**To:** Patricia Davis, P.E., Brad Marshall  
**From:** Jonathan Tran, P.E. / Charles Cameron  
**Copy:** Matt Gaughan, P.E.  
**Date:** June 11, 2020  
**Subject:** CWWTP1 Change Order 0001

For the Central Wastewater Treatment Plant Expansion project, the Owner's Representative Team recommends approval of the attached Change Order 0001 in the amount of \$288,607.76 and 34 additional days to the contract with BAR Constructors, Inc. for the nine items in Table 1 below.

<b>Project:</b> <u>Central Wastewater Treatment Plant</u>	<b>Project Number:</b> _____
<b>Owner:</b> <u>City of Pflugerville</u>	<u>88</u>
<b>Contractor:</b> <u>BAR Constructors</u>	<u>279</u>
<b>Engineer:</b> <u>Freese and Nichols</u>	<u>PFL16607</u>
<b>PCM:</b> <u>Plus Six Engineering</u>	<u>19-211</u>

**Change Order No.:** 001      **Date:** 06/11/2020

CITY OF PFLUGERVILLE  
 CENTRAL WWTB EXPANSION  
 PHASE I IMPROVEMENTS  
 STRUCTURAL  
 UV DISINFECTION BASIN & SYSTEM  
 TOP PLAN

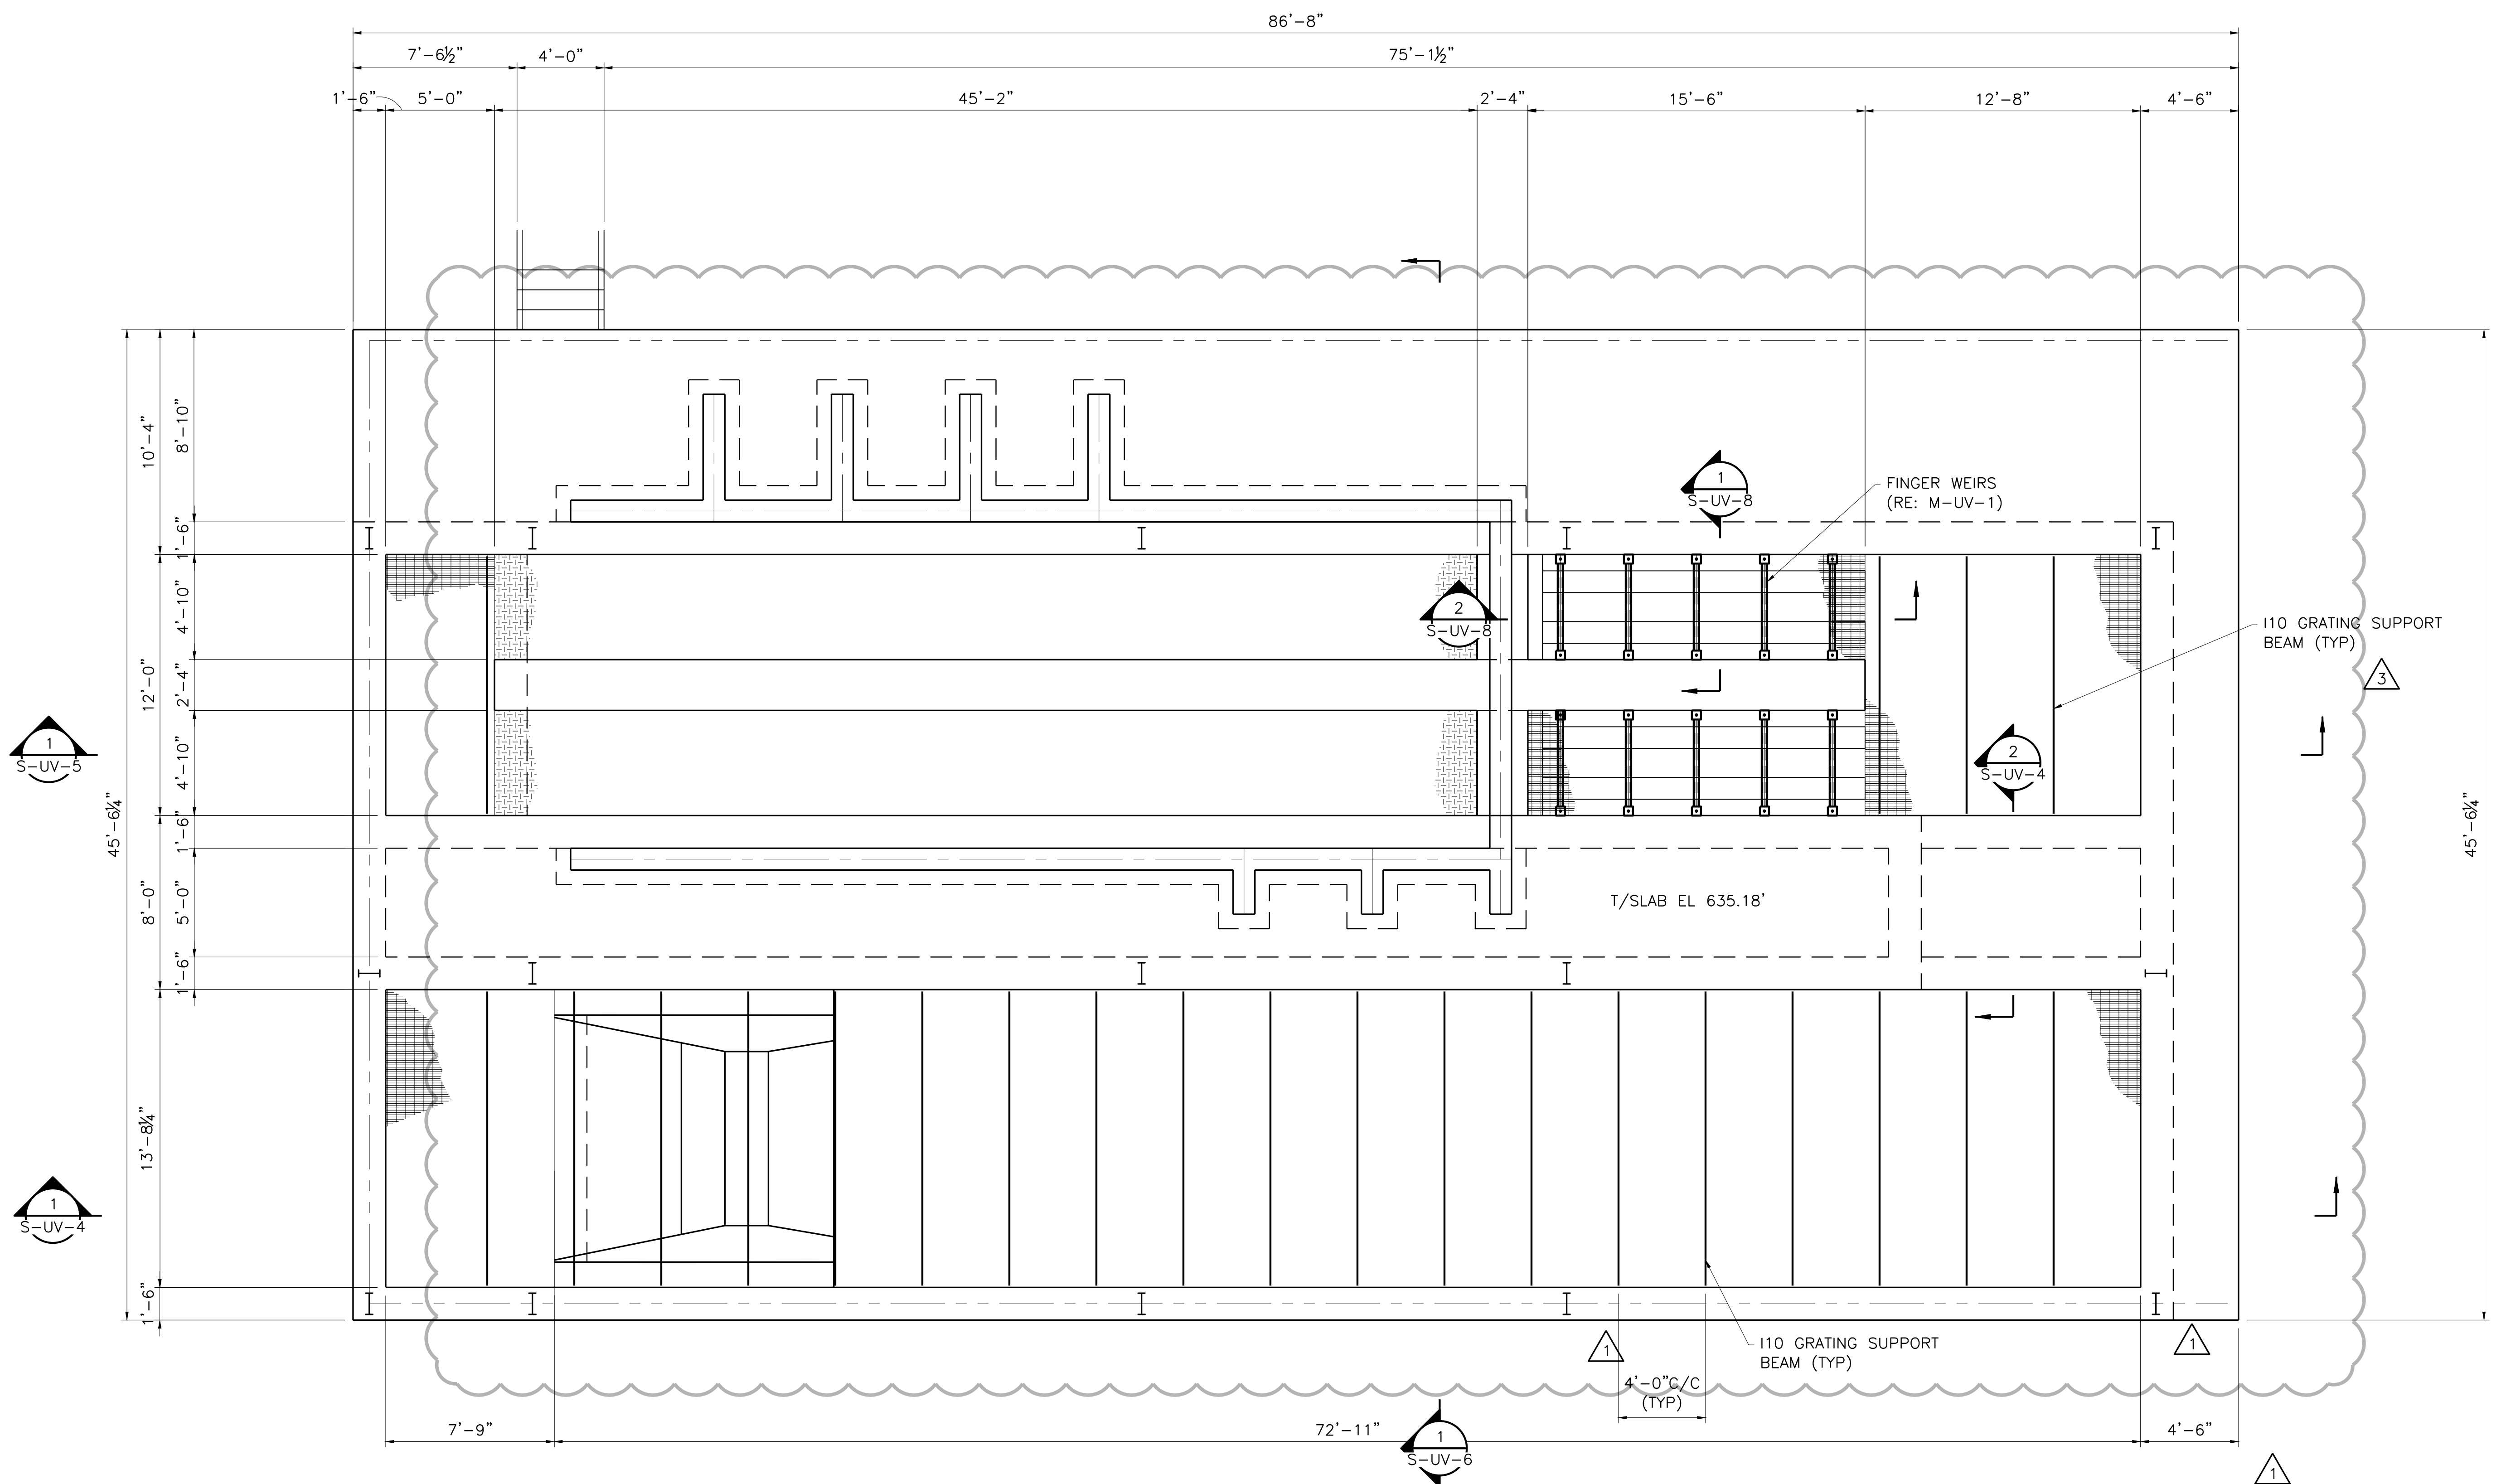
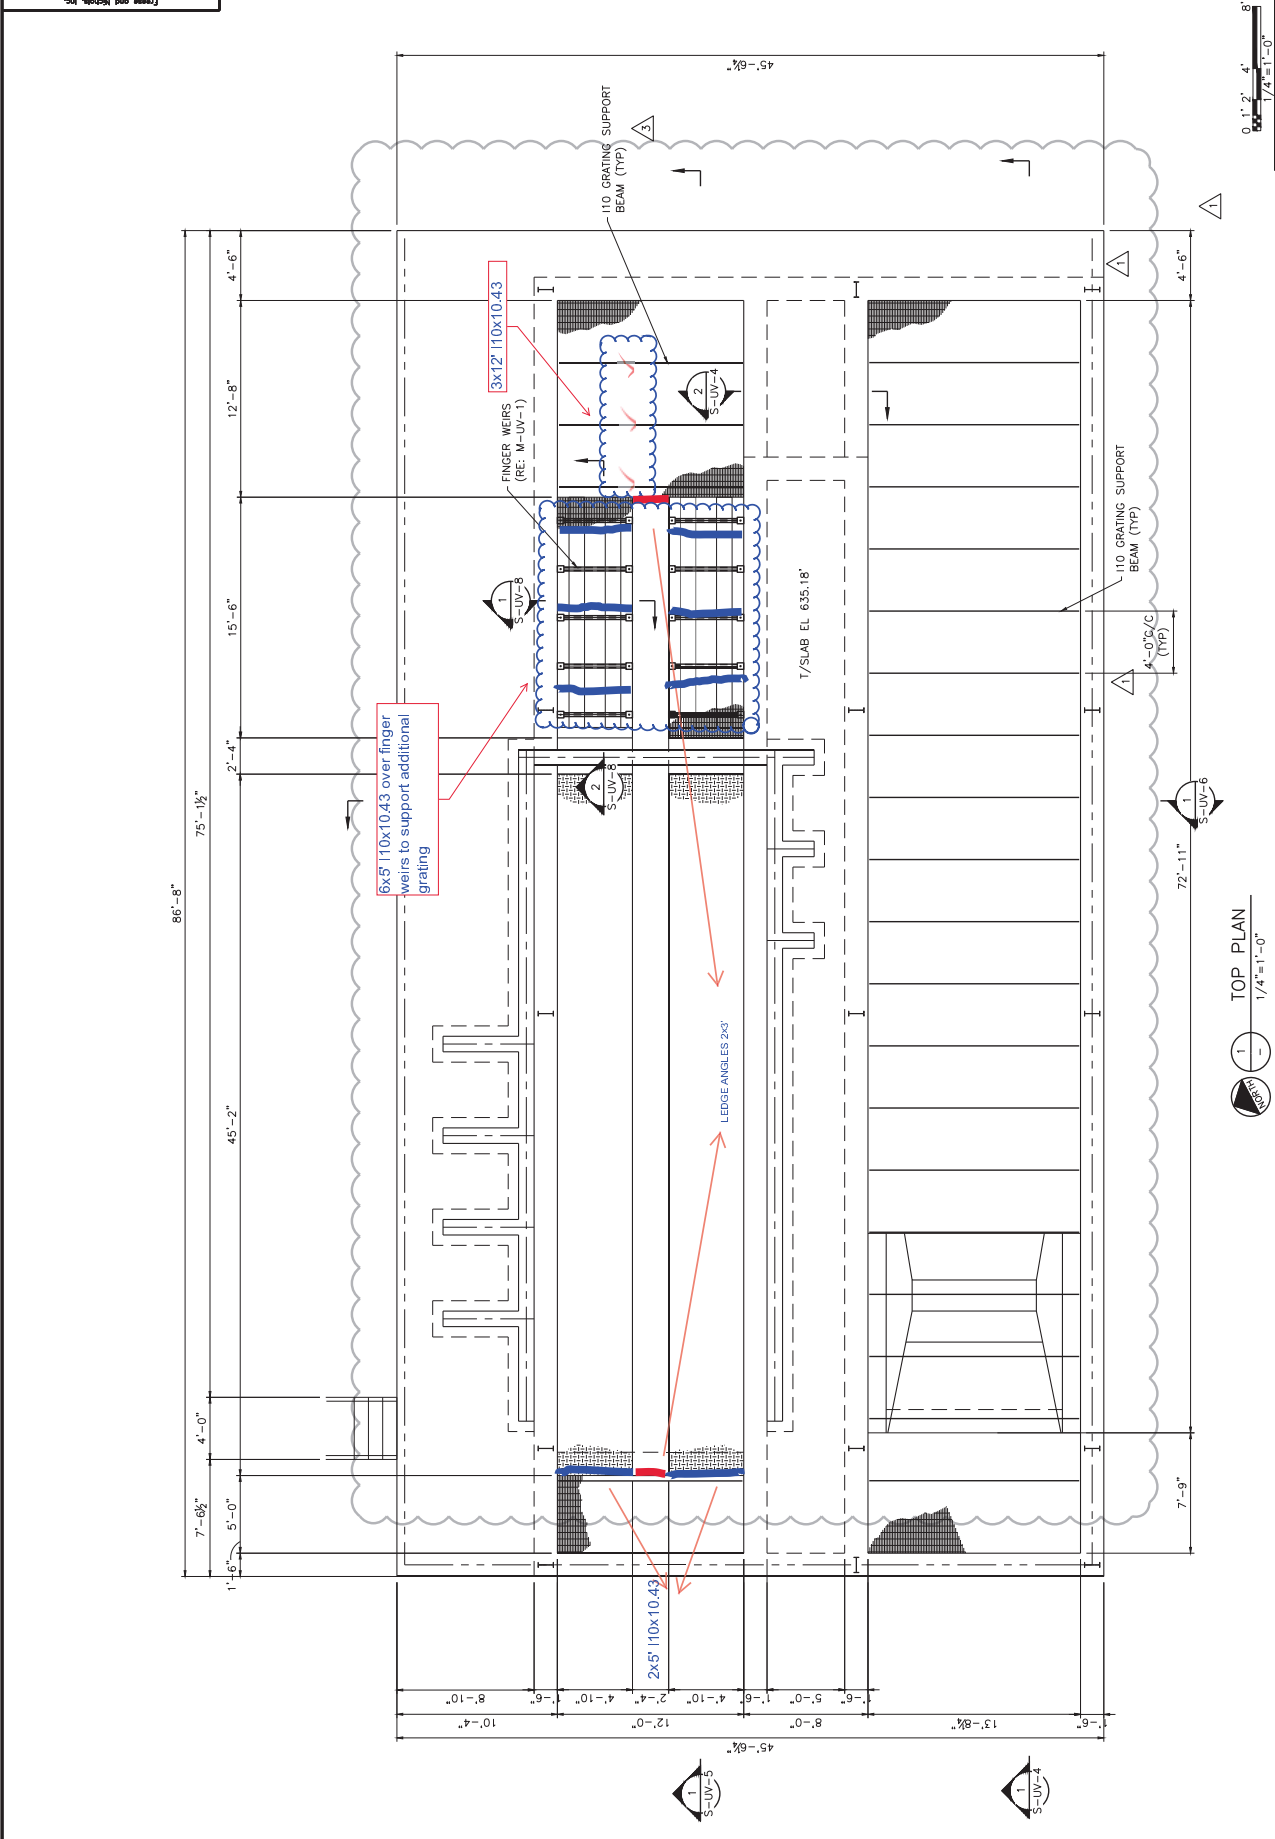
Modifications to sheets S-UV-1 to S-UV-8 to clarify sections and details of the design.

This change order request includes change of aluminum support beams, additional grate over finger weirs.

10431 Avenida Cibola, Suite 300  
 Austin, Texas 78758  
 Phone - (512) 617-3100  
 Fax - (512) 617-3101

1 MODIFICATIONS PLAN  
1/4" = 1'-0"

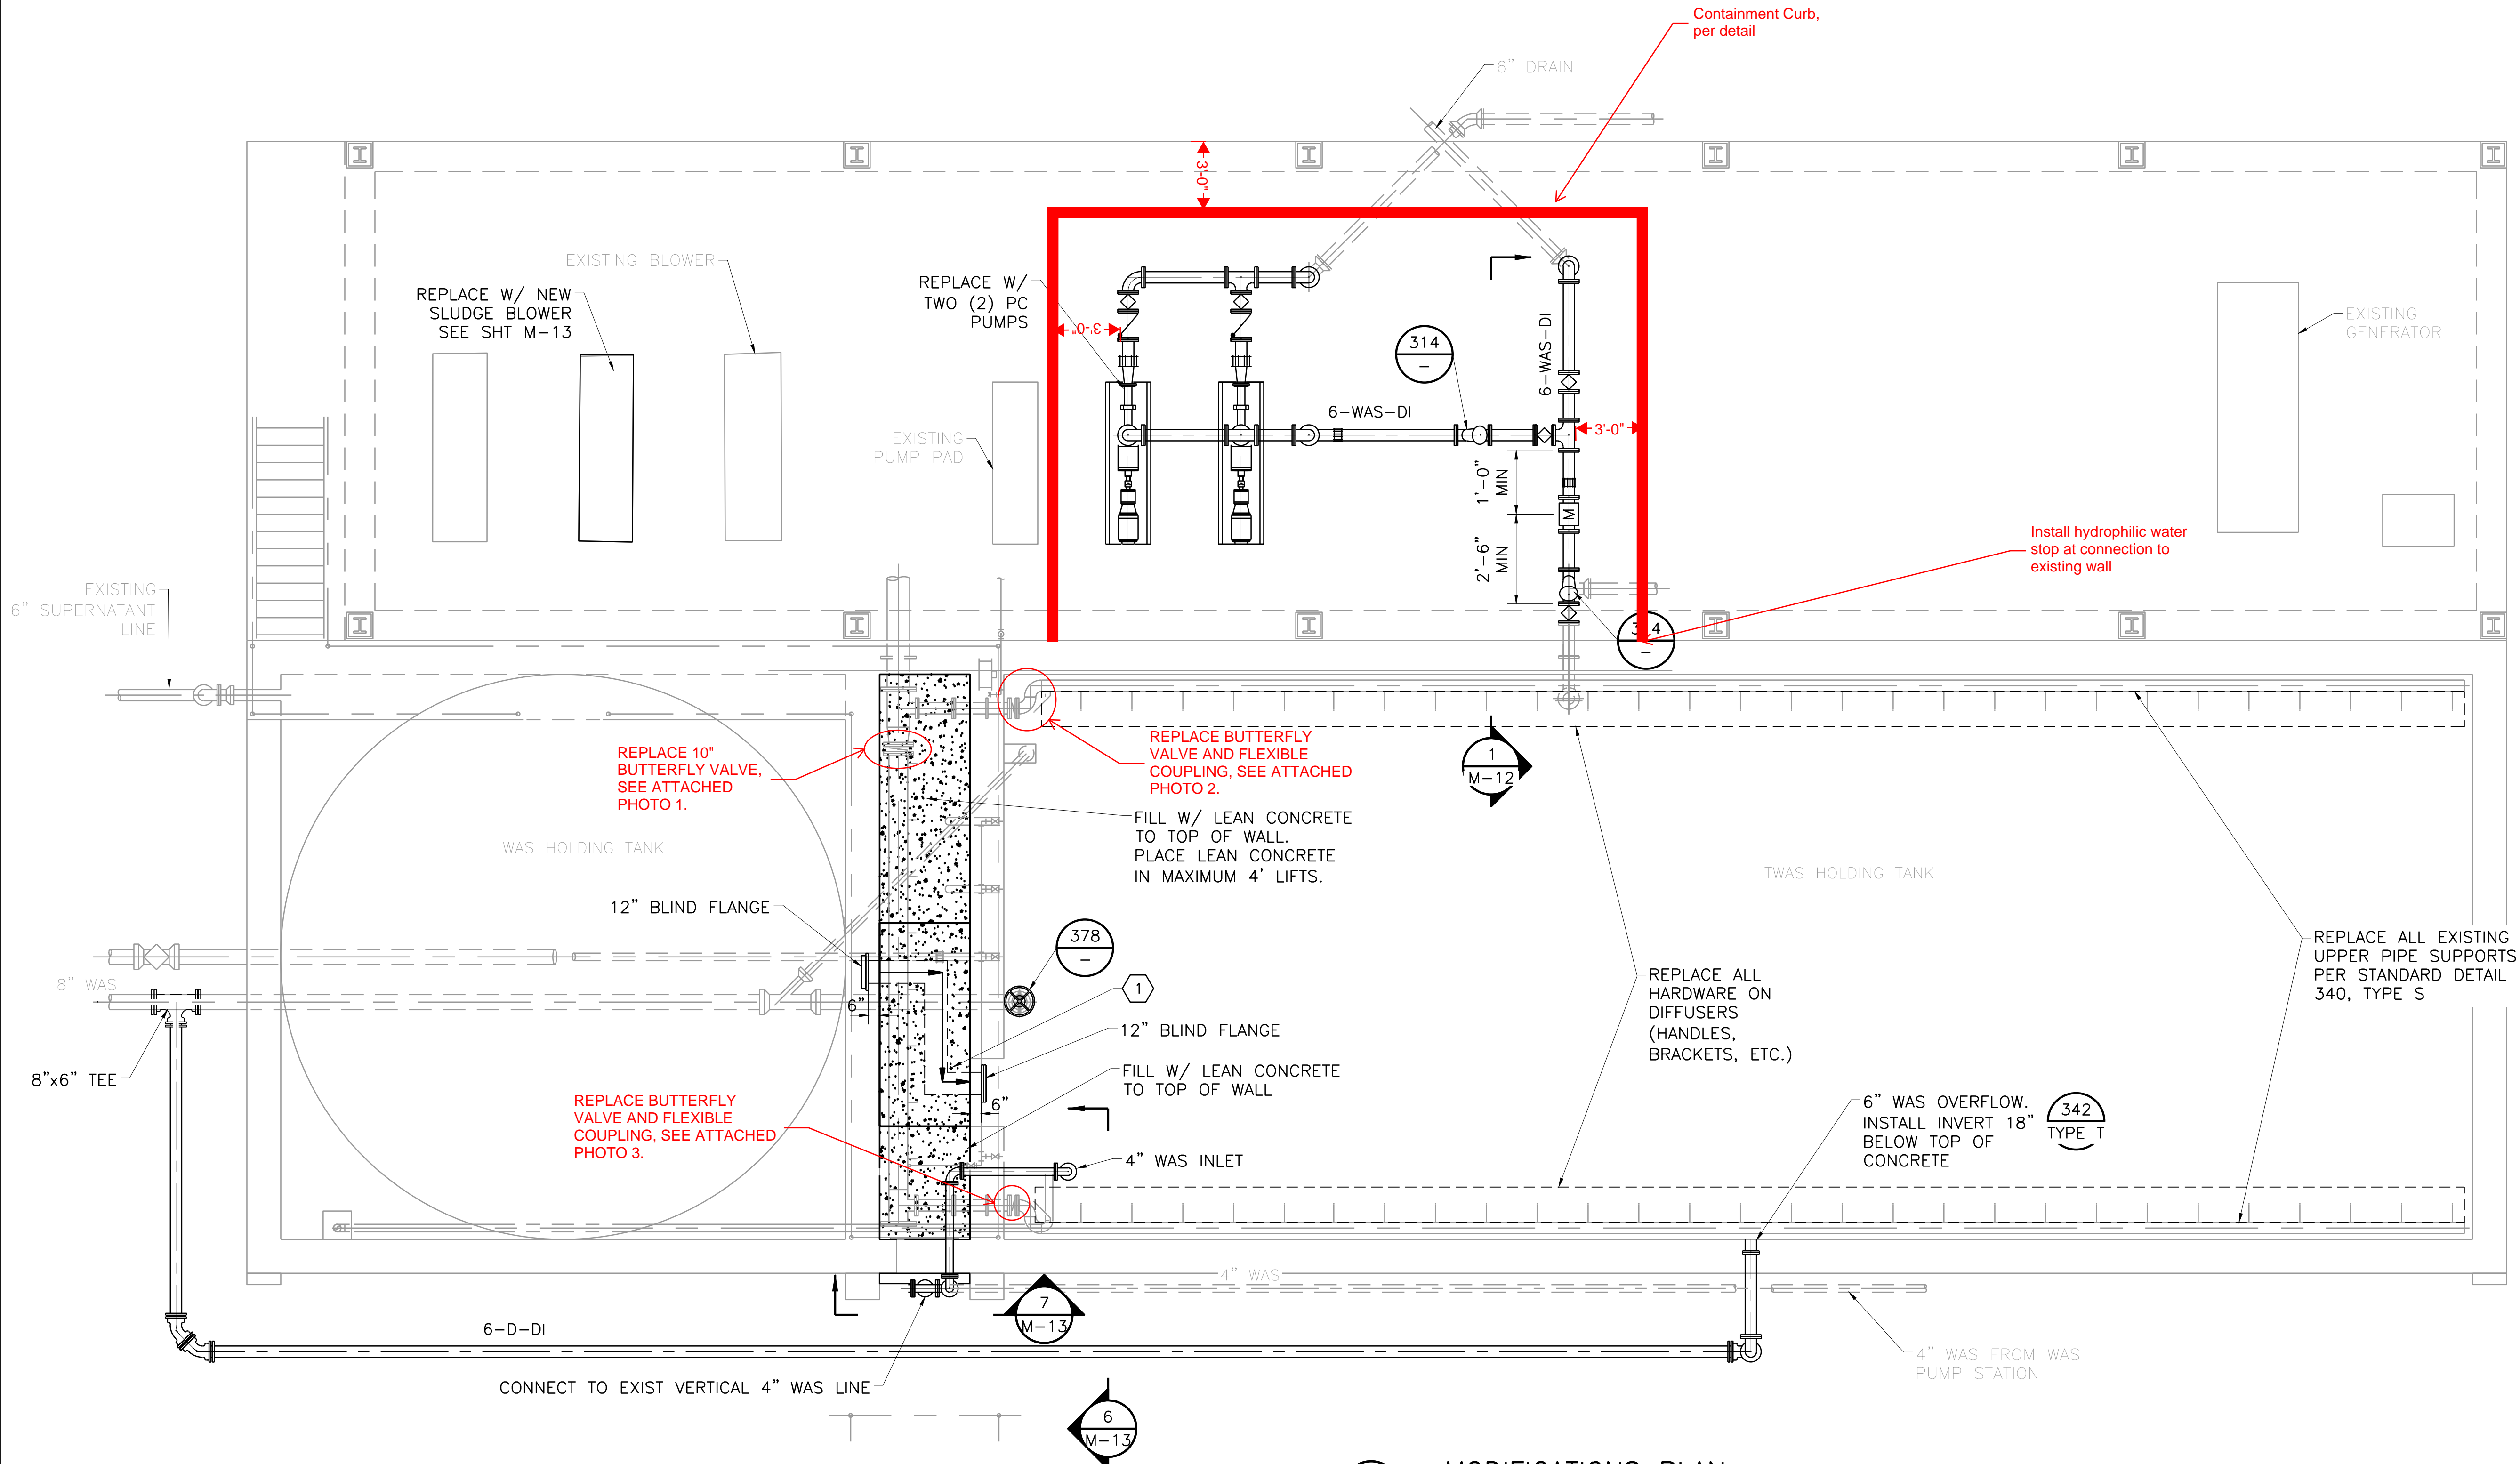
Installation of 6" concrete containment curb around progressing cavity pumps in solids handling area. Reference attached markups.

- Roughen slab under proposed curb
- Install dowels as required by detail
- Form and pour containment curb around pumps.

Replacement of leaking valves and couplings on sludge holding tank air header.

- Replacement of 10" SS flange and flange adapter
- Replacement of two (2) 6" SS butterfly valves
- Replacement of two (2) 6" SS "Dresser-Style" flexible couplings

ITEM 4: CONTAINMENT CURB DETAIL

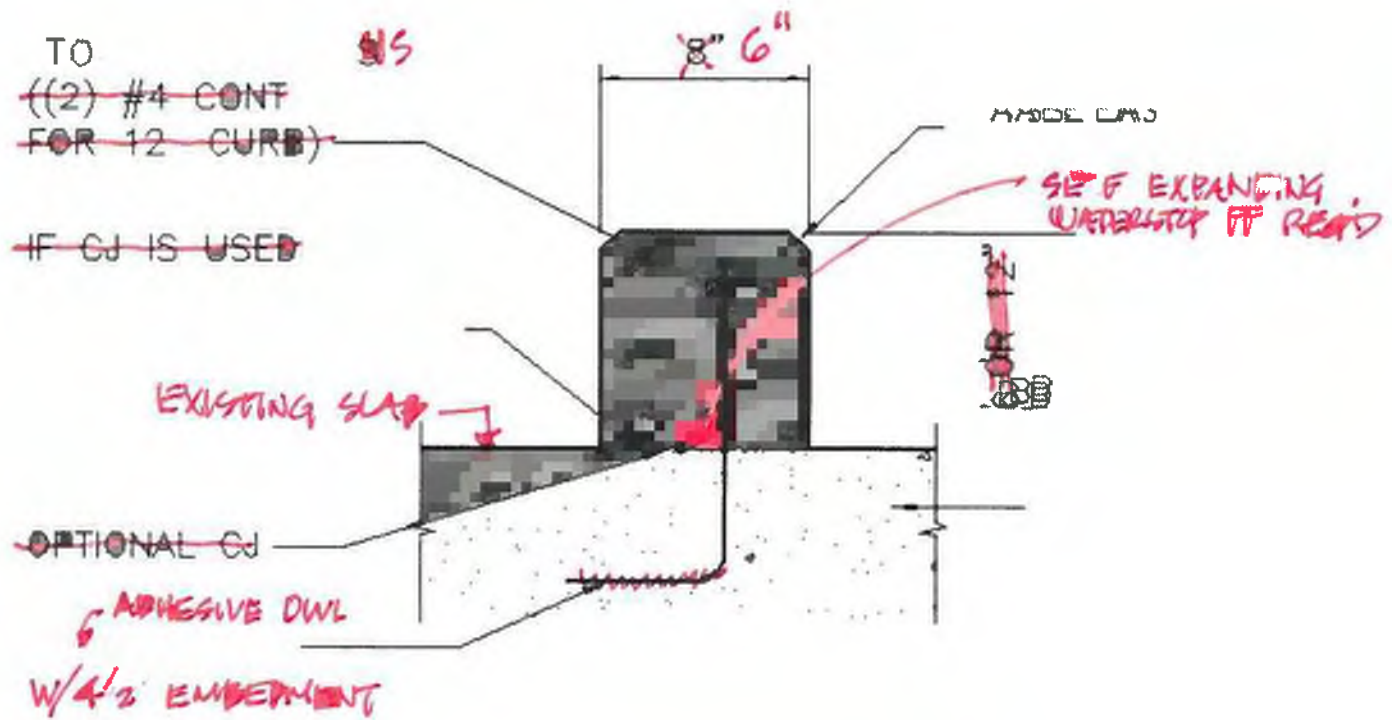
~~DETAIL NOTE:~~  
~~12\" CURB REQUIRED AT HEADWORKS ONLY~~  
~~UNLESS NOTED OTHERWISE. 6\" CURB TYPICAL.~~
